Application Number A006992815

13 KENT ST HAMILTON QLD 4007 - Carry Out Building Work; Material
Change of Use

Response to Assessment Report prepared by Planning Initiatives and dated 25 March 2026.

East Elavation of The Gallery with approximate winter morning sun shadows from proposed development 13 Kent Street

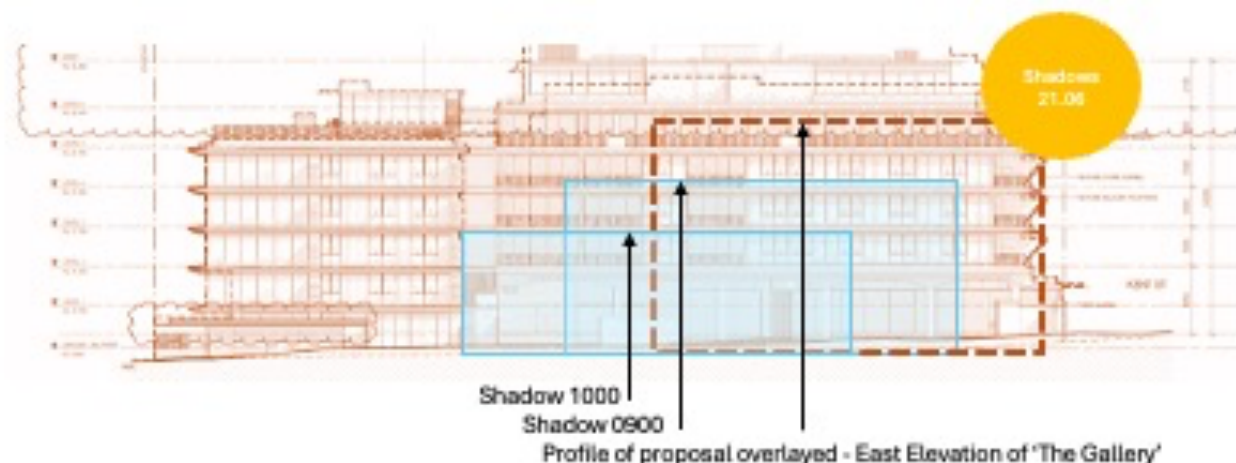
The proposal will adversely impact the residents of the mixed use development to the west (63-71 Racecourse Rd) and their enjoyment of the subtropical climate. Levels 2-5 have apartments facing east. For 10 of these apartments the only access for natural light and ventilation is the eastern elevation of the building.

The height above 11.5m and reduced boundary clearance of the proposal will have adverse climatic impacts. As follows

- 6 apartments will not receive winter sun (21.July) before 0900 am
- 3 apartments will not receive winter sun (21.July) before 1015 am (note that winter sun on this elevation ceases at 1140 am)
- access to favourable north-east and south-east breezes will be disrupted.

These impacts would be substantially mitigated if the proposal complied with LMR2 and Multiple Dwelling Code height and setback requirements.

Applicants Drawing A-2103

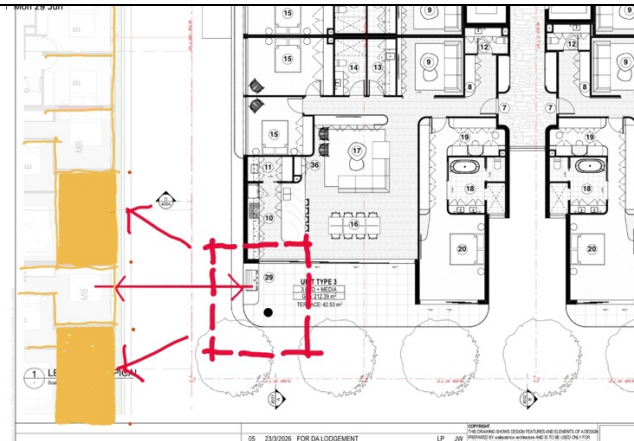
Balconies on the south-western corner of the proposal are:

- open and unscreened to the west.
- 2.5m from boundary and 7m from balconies of adjoining units

The site planning in this vicinity provides no possibility for screen planting or deep planting.
